# Millstone Nuclear Power Station

## Unit 1

### Northeast Utilities Quality Assurance Program Topical Report

Rev. 0 Change 1  
10/25/99

**Organizational Relationship  
of Functional Groups Having Quality  
Functions for Millstone Unit 1**

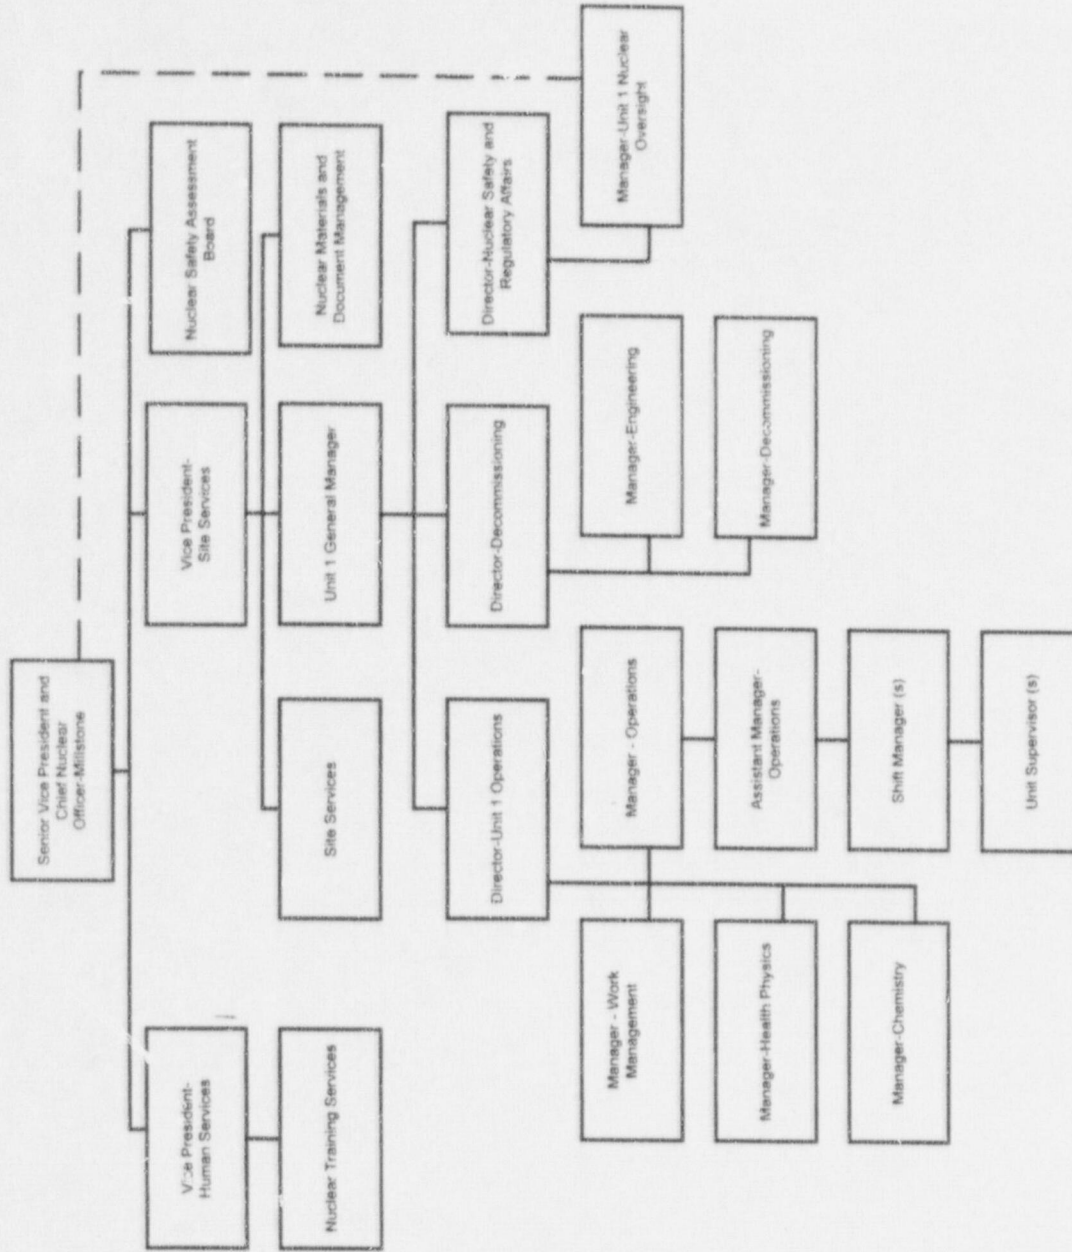
1.4.8	Revised text to more specifically describe Unit 1 Operations organization and responsibilities.	NUQAP Change Request 99-22
1.8	Replaced organization charts with one chart that describes only those organizations with quality-related responsibilities for Unit 1.	NUQAP Change Request 99-22
